Re: Pulte @ Mirehaven Phase 2 (DRB # 1006864) – Supplemental Submittal

PULTE @ MIREHAVEN PHASE 2  
GRADING PLAN

**Re: DMP for Pulte @ Mirehaven Phase 2  
N-2-D of the Watershed Subdivision  
Engineer's Stamp Date 7/18/2015 (H09/D017E)**

CITY OF ALBUQUERQUE  
DEPARTMENT OF  
MUNICIPAL DEVELOPMENT  
PULTE @ MIREHAVEN PHASE 2  
GRADING PLAN

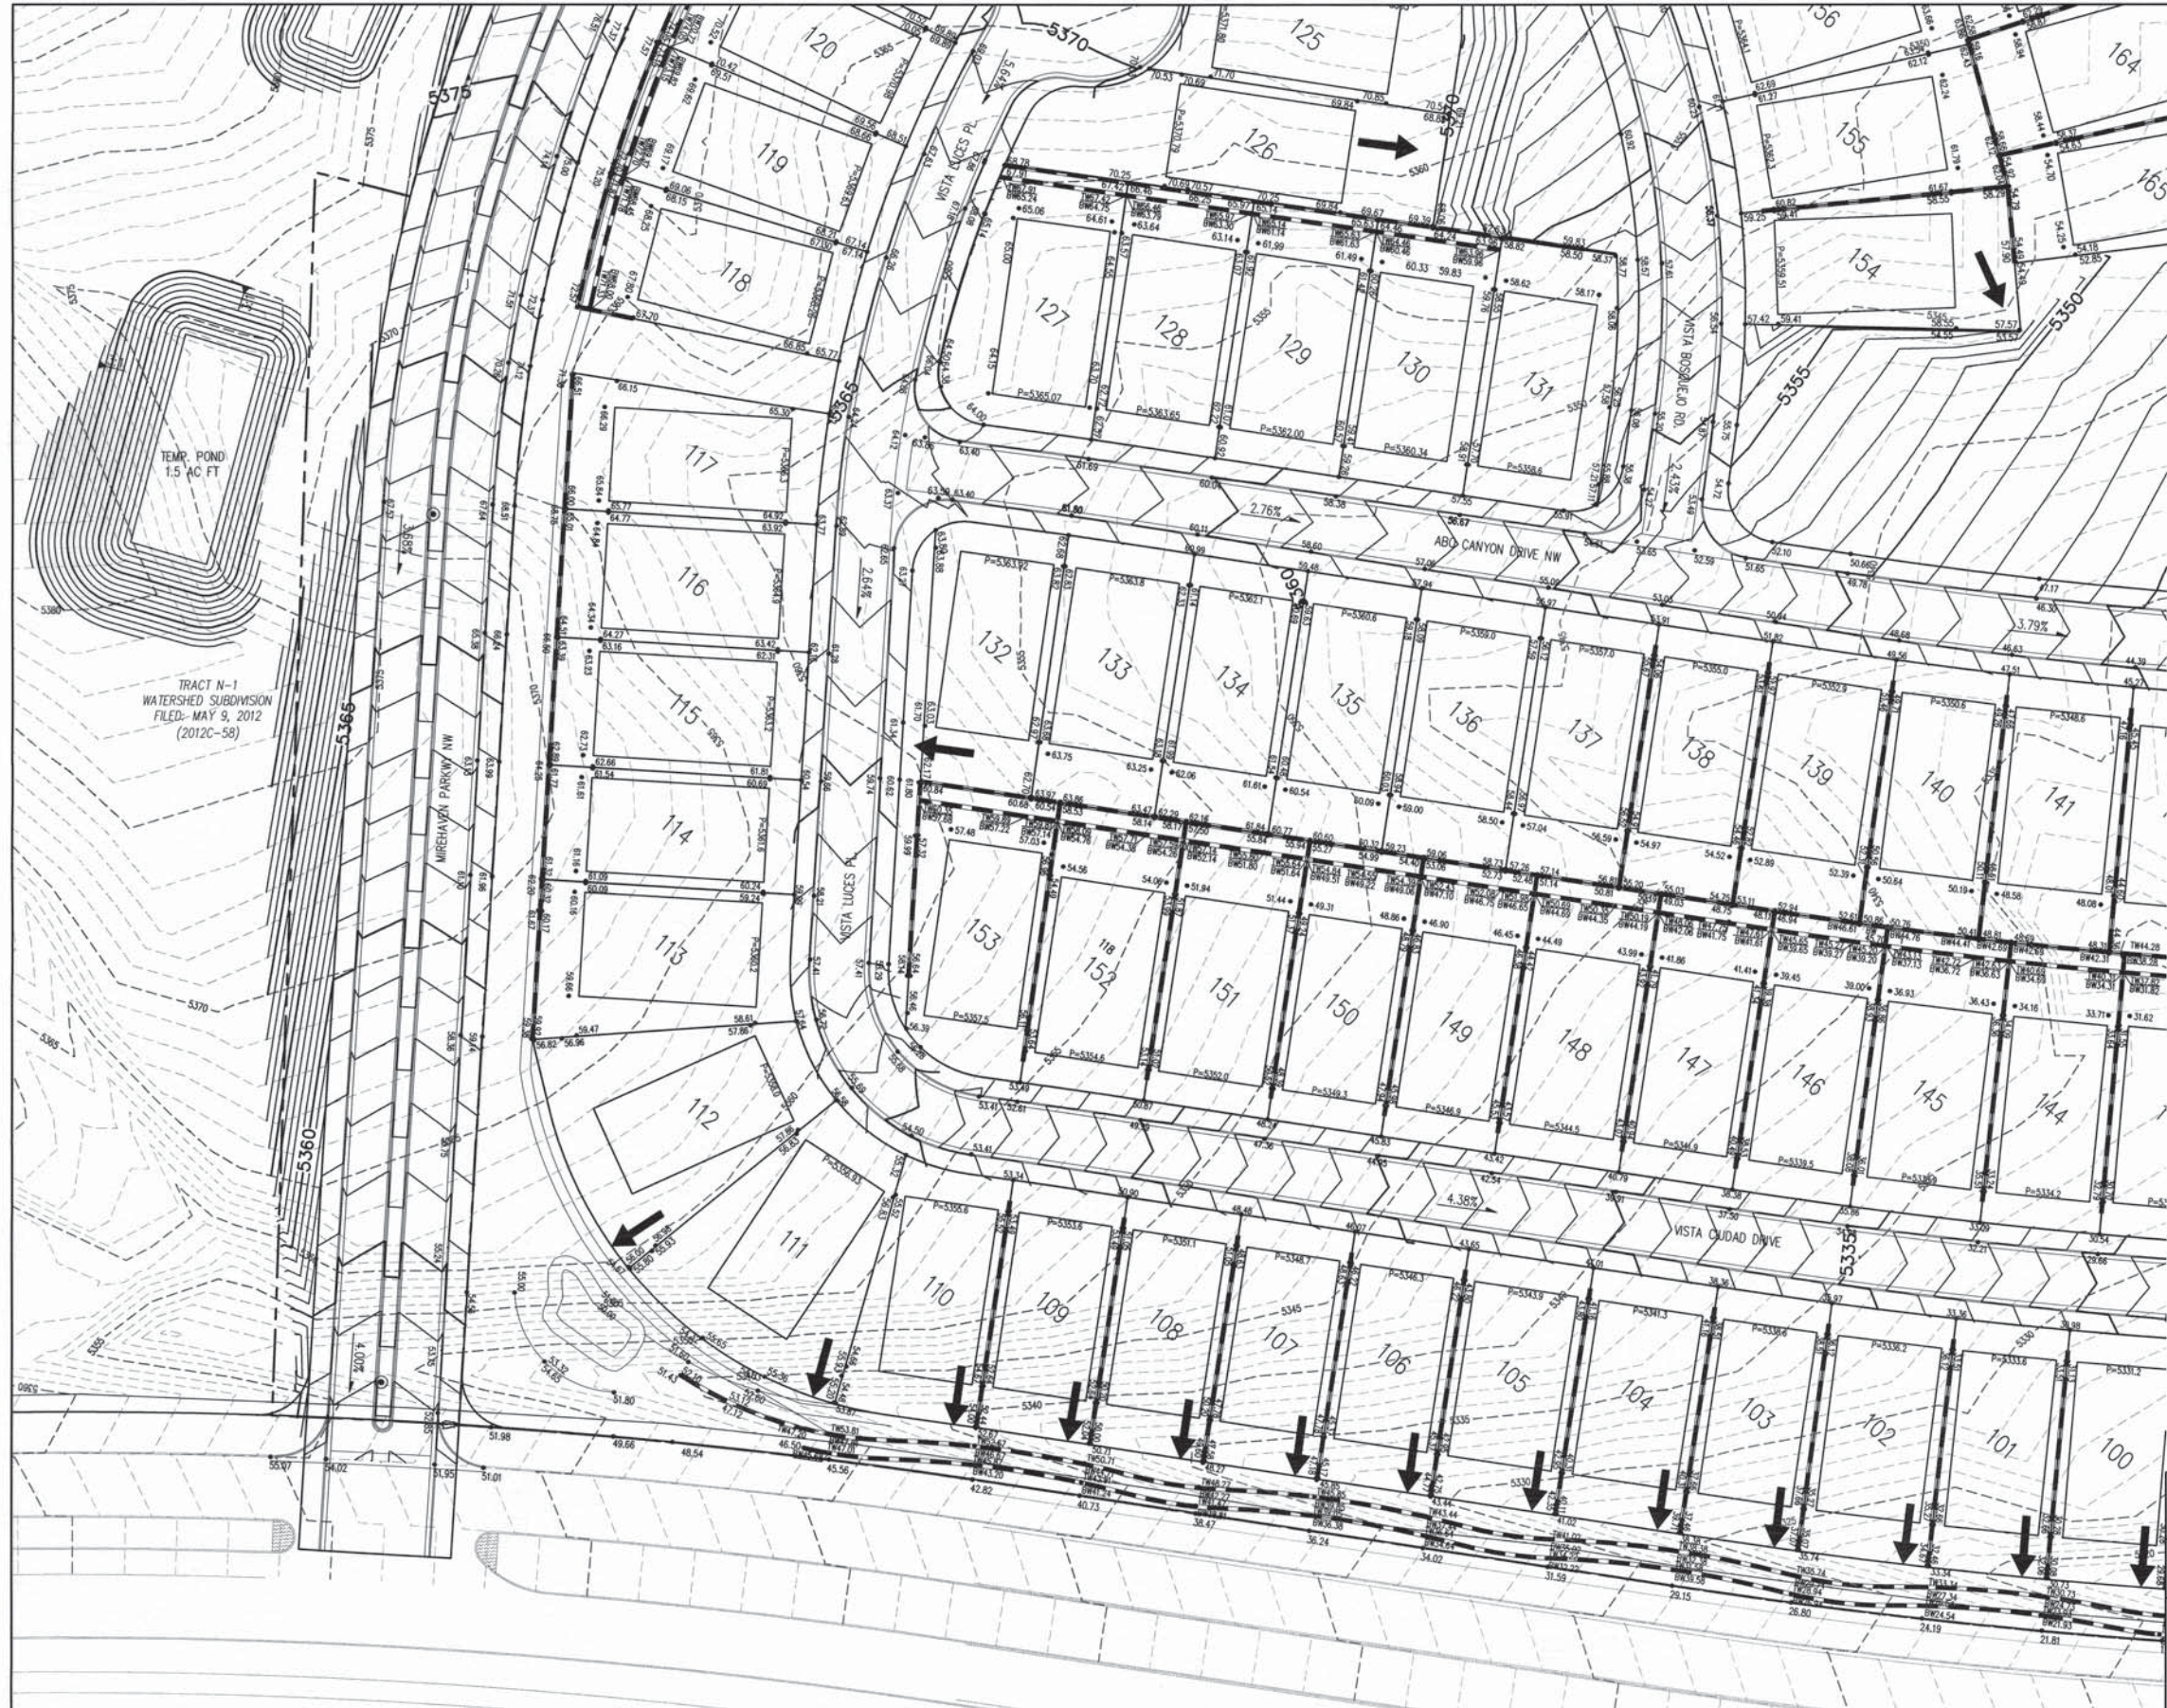
1. Check grades approaching intersections. Grades may be exceeding 4% on the lower side of the streets.
2. Proposed ponds intercepting offsite flows from basins O-1 to O-5 do not fully capture the runoffs. Good portion of basin O-2 drains to Mirehaven Parkway. How is the sediment/erosion being handled for the large slope/graded area to the west of Mirehaven Parkway. Please move the diversion channel closer to Mirehaven Parkway? Label proposed contours. Make sure that proposed contours tie to existing grades.

3. Diversion channel will drain offsite basins O-1 and O-2 to an existing pond. What is the total volume being captured and what is the capacity of this pond?

4. Who will be maintaining the temporary drainage improvements? A Drainage Maintenance and Covenant may be required.
5. How is the offsite runoff south of Basin O-5 being handled?

6. Based on the Drainage Master Plan there are proposed storm drain pipes within Mirehaven Parkway. Please provide street capacity calculations. Are inlets required? Provide storm drain pipe calculations. All improvements within Mirehaven Parkway must be included on the infrastructure list.

7. How does Basin C4 (under the Drainage Master Plan) drain to the storm drain system?
8. Total proposed runoff from this subdivision is slightly higher than what is shown on the Drainage Master Plan. Would this cause any capacity issues for the constructed storm sewer infrastructure downstream?

9. Provide an exhibit which clearly shows runoff, depth of water, and street slopes upstream and downstream of all the inlets. Double check on the flows being intercepted and bypassing the inlets.

10. Check grades west of lot 56. Retaining wall may be required.

11. Provide bottom and top wall elevations for all the proposed retaining walls.  
Please make sure all grades are clearly shown. Double check the height of the walls to make sure that does not exceed 8' in height.

12. Provide the height of the garden wall on the sections shown on the plans. What is the spacing between the walls? Retaining walls are being proposed in the middle of the 10' PUE.

13. Some lots are graded to drain to the back of the lots. Only the rear landscaping areas can drain to the back. The side yards and the house must drain to the front of the lots. Roof drains may be needed to assure that the runoff would drain to the front of the lots. There must be drainage easements on top of the tracts where rear lots drain to.

14. What is the size of the pond located at the northwest corner of Tierra Pintada and Mirehaven Parkway? How much runoff enters this pond.
15. First flush pond details and calculations must be provided. Area between back of curb & gutter and sidewalk must be depressed. Ponding also must be provided behind the sidewalk within the front yard (low side) of lots. The pond must be at least 12" deep. Please include driveways areas as part of the first flush required volume calculations.

16. Can the street grades be modified so a maximum slope of 5% is maintained throughout the subdivision?
17. There are some overlapping texts throughout the grading plan. Please make sure all texts are legible.

18. Check grades west of Lot 6.
19. Since the site will be disturbing more than one acre An Erosion and Sediment Control plan will have to be approved prior to grading approval.
